# Access Compliance Report

## Public Rights-of-Way

### (Curb Ramps)

Intersection ID: 18726	Main Street: TYVOLA_RD	Cross Street: OLD_PINEVILLE_RD	Location: SE
ADA ID: 76225272C627	Ramp Type: Perp	Initial Pass/Fail: Fail	Overall Compliance: No
Severity Score: 12.5			
Codes/Mitigation Info/Possible Solution		Field Measurements/Component Compliance

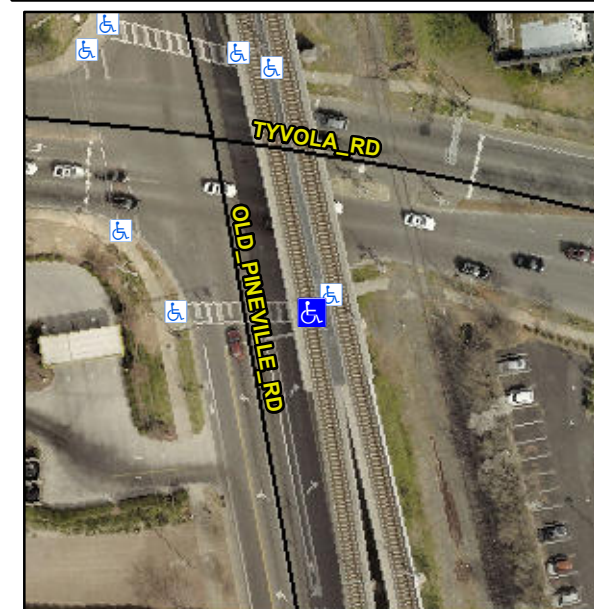
**Not Found, R304.2.2**

Compliance	Description	Data	Compliance	Description	Data
N/A	Ramp Length (in)	100.0	No	Ramp Slope (%)	8.7
Yes	Ramp Width (in)	48.0	Yes	Ramp XSlope (%)	1.6
N/A	Flare Type LT	N/A	N/A	Flare Type RT	N/A
N/A	Flare Slope LT (%)	N/A	N/A	Flare Slope RT (%)	N/A
N/A	Flare Traversable LT?	N/A	N/A	Flare Traversable RT?	N/A
N/A	Landing Length (in)	N/A	N/A	DWS Provided?	N/A
N/A	Landing Width (in)	N/A	N/A	DWS Contrast?	N/A
N/A	Landing Slope (%)	N/A	N/A	DWS Length (in)	N/A
N/A	Landing X Slope (%)	N/A	N/A	DWS Full Width?	N/A
N/A	Landing Curb? (Y/N)	N/A	N/A	DWS Offset (in)	N/A
N/A	Shared Landing?	N/A			
N/A	Gutter Ponding?	N/A	N/A	Gutter Slope (%)	N/A
N/A	Gutter Lip Ht (in)	N/A	N/A	Gutter X Slope (%)	N/A
N/A	Painted X Walk1?	Yes	N/A	Painted X Walk2?	N/A
	X Walk 1 Direction	To W		X Walk 2 Direction	N/A
N/A	X Walk 1 Width (in)	111.0	N/A	X Walk 2 Width (in)	N/A
	X Walk 1 Slope (%)	2.3		X Walk 2 Slope (%)	N/A
	X Walk 1 X Slope (%)	1.2		X Walk 2 X Slope (%)	N/A

**Remove & Replace Entire Ramp.**
